Sequence IV Surveillance Panel | MINUTES

Relevant Test:	Sequence IVA and IVB
Note Taker:	Chris Mileti
Meeting Date:	07-26-2017
Comments:	Conference call to discuss preparations for upcoming Sequence IVB prove-out testing.

2.1. Intertek Experiments with Lubrizol Oil Pan:

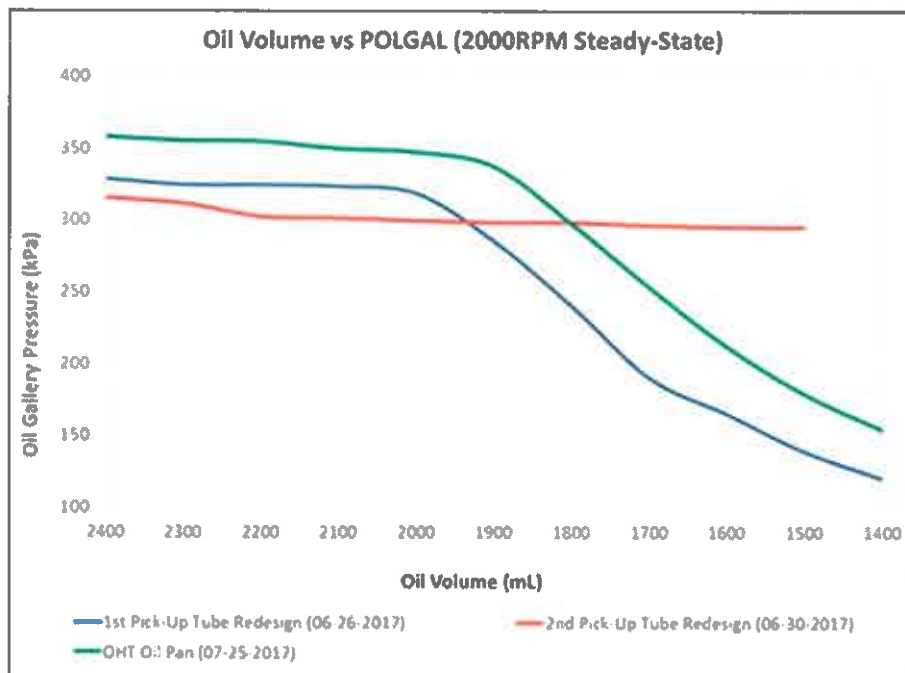
- 2.1.3.2. The Lubrizol oil pan design (with an oil well) significantly improves oil pressure at extremely low oil volumes (<1400mL).
- 2.1.3.3. The improvement offered by the Lubrizol oil pan design becomes less significant at higher oil volumes (~10kPa at 2400mL).

- 2.1.3.4. The stock IVB oil pan and the Lubrizol oil pan generate similar oil pressures at an oil volume of 3000mL.
- 2.1.3.5. It is unlikely that the oil volume of a Sequence IVB test will drop below 1800-2200mL with the larger initial oil volume of 3000mL.

- 2.1.3.5.1. The Lubrizol oil pan does show a significant improvement in oil pressure within this range of volumes.
- 2.1.4. **Lubrizol's Comments about the Intertek Trial:**

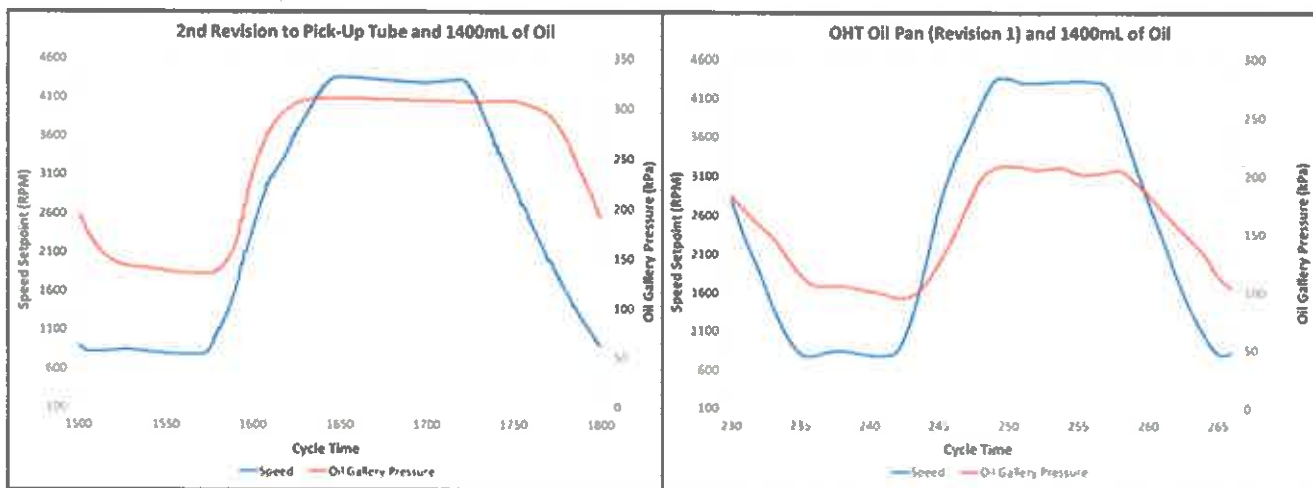
2.2.3.3. The slotted designs (OHT slotted design is shown in right-side chart) do not seem to generate oil pressures that are as good as the oil-well design (shown in left-side chart) under dynamic conditions and extremely low oil volumes.

2.2.3.4. The slotted pick-up tube designs appear to exhibit a reduction in oil pressure when the oil volume drops below 1800-1900mL.

2.2.3.5. However, with the Sequence IVB's new initial oil charge of 3000mL, it is unlikely that the oil level will ever drop below 2000mL.

2.2.3.6. Thus, the OHT design will probably be sufficient at preventing oil pump starvation.

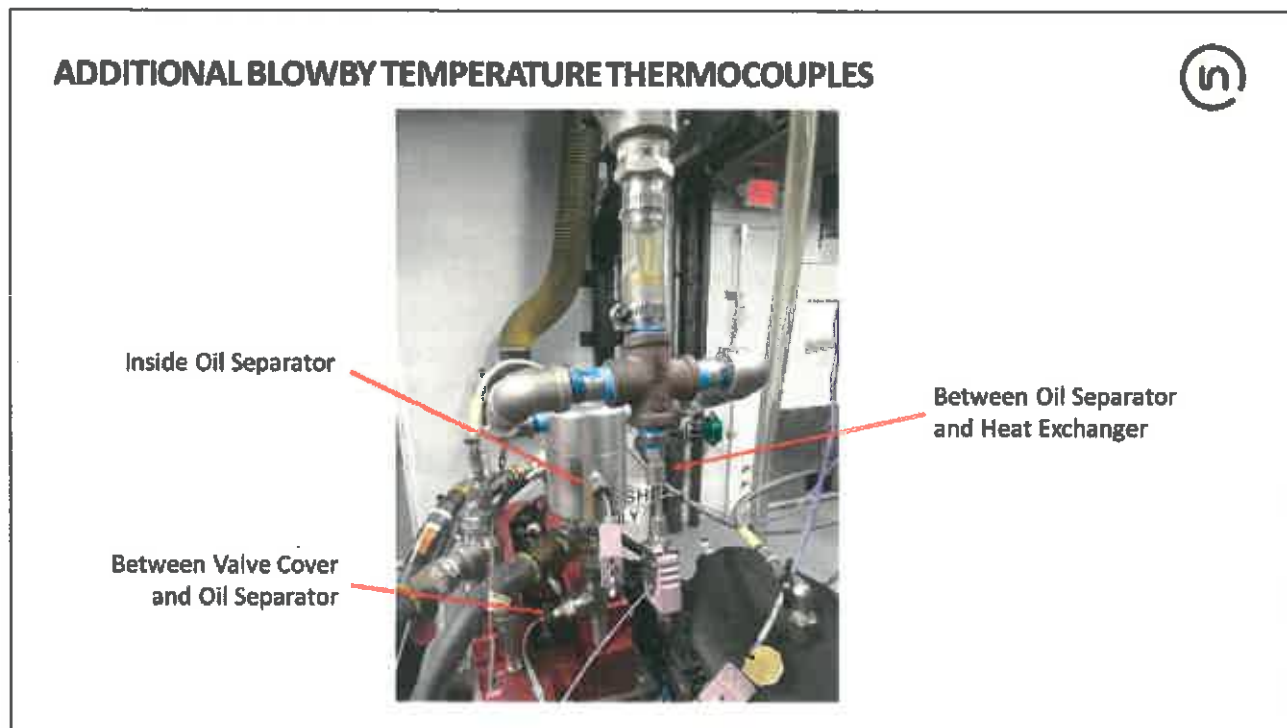
2.4.4.1. OHT is currently modeling an oil pan displacement block.

2.4.4.2. OHT is also modeling an oil well below the pick-up tube.

2.4.4.3. The slotted pick-up tube design has the shortest lead-time, and that is why OHT decided to use it for the oil pan.

2.4.4.4. Now that this motion is approved, they will start modifying the existing oil pans in their inventory and at the labs.
